ADDRESS . . : 89922 \*UNASSIGNED SUBDIV:  
 CONTRACTOR : KEITH BULLOCK BUILDERS INC. PHONE : (919) 639-7424  
 OWNER . . : BRYAN CHARLES & LINDA PHONE : (919) 557-5050  
 PARCEL . . : 05-0642- - -0003- -14-  
 APPL NUMBER: 10-50023623 CP NEW RESIDENTIAL (SFD)  
 DIRECTIONS : T/S: 01/19/2010 11:33 AM RDCONTE ---  
 194 JACKSON ROAD  
 TAKE 401 N TOWARDS FUQUAY. T/L ON  
 CHRISTIAN LIGHT ROAD. GO APROX 1.5MI,  
 T/L ON JACKSON ROAD. 194 JACKSON IS AT  
 THE 2ND GROUP OF MAILBOXES ON THE  
 RIGHT.

Reference: Inspection Issues  
Plan: DK 2859  
Project No. 10GAR-R0009

Reference: Attic Framing  
Plan: DK 2859  
Project No. 10GAR-R0009

FRAMING AT STEEL BEAM

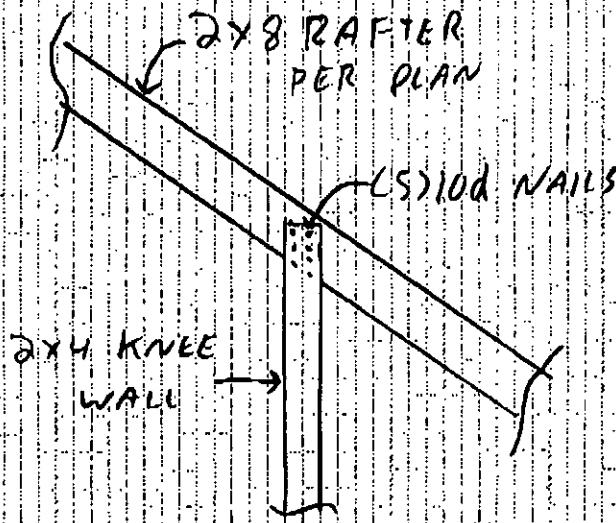
- 1) Garage stud wall height of approximately 12'-0".
- 2) Floor joist connection to W8x21 in Family Room.
- 3) Knee wall connection to roof rafters in second floor.
- 4) Connection between rear Covered Porch header and rear Screened Porch header.

- 1) Based on our plan review and analysis, the 12'-0" tall studs shall be either 2x6 @ 16" o.c., or (2)2x4 @ 16" o.c. For the (2)2x4 option, the studs may be framed side-by-side or as a "T" section. The plan specified beam stud columns are adequate as framed.
- 2) The web of the W8x21 shall be packed out with 2x lumber. The floor joists shall bear on a ledger. See sheet 3 for required framing detail
- 3) The rafters may be nailed to the 2x4 knee wall studs in lieu of bearing on top of the knee wall. The rafters must be secured with minimum (5)10d nails at each connection. See sheet 3 for required framing detail.

| 4                           |          |                               |                 |      |
|-----------------------------|----------|-------------------------------|-----------------|------|
| PROJECT: PARTIAL ATTIC PLAN |          |                               | DRAWING NUMBER: | REV. |

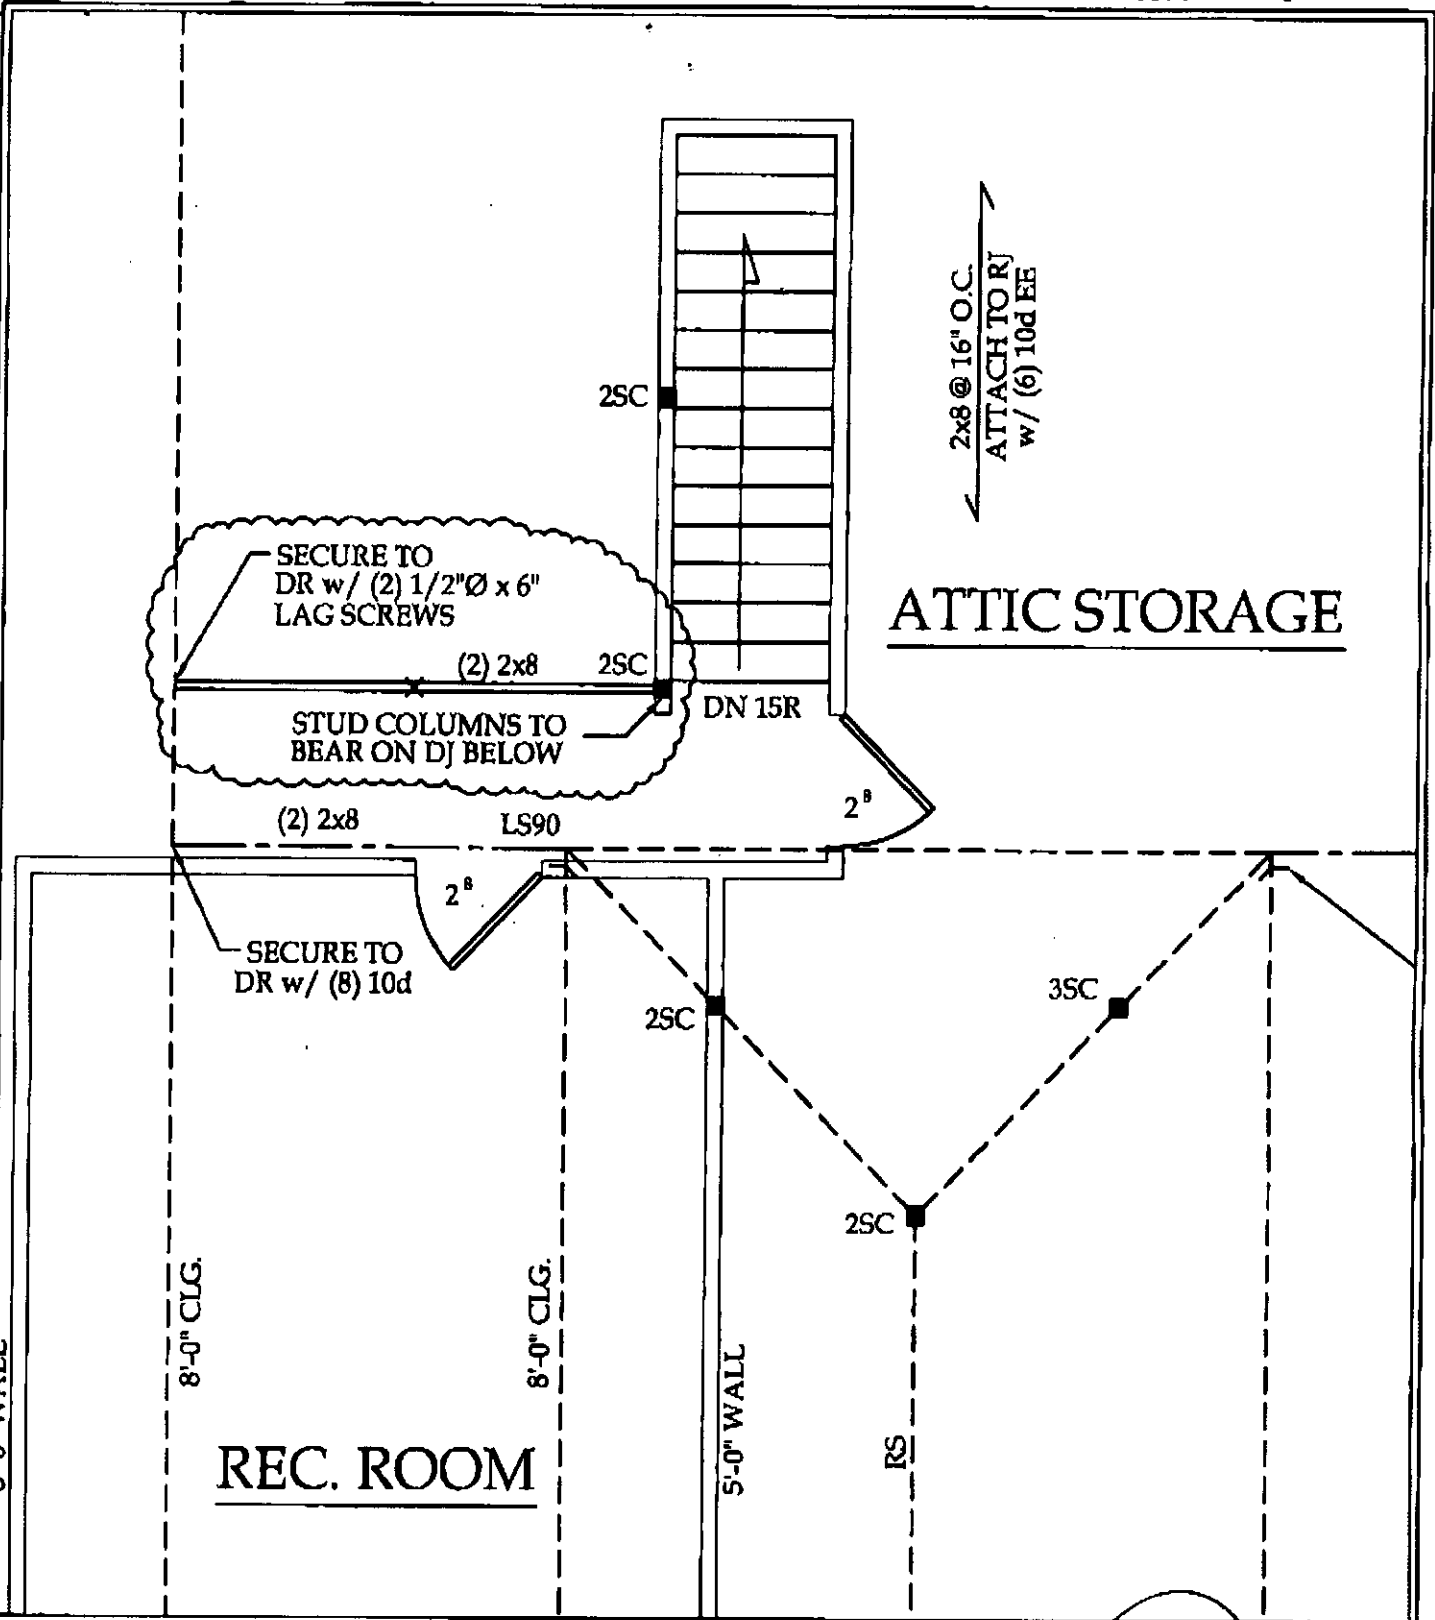
- 1) Framing in attic near stairs.

- 1) Based on our plan review and analysis, the plan specified wall in the attic near the stairs may be removed. The plan specified point load shall be supported by (2) 2x8 ceiling joists. The double 2x8 ceiling joists shall be secured to a (2)2x8 rafter with (2)1/2" x 6" lag screws. The reader is referred to the attached pages. These changes will adequately support the anticipated loading conditions.
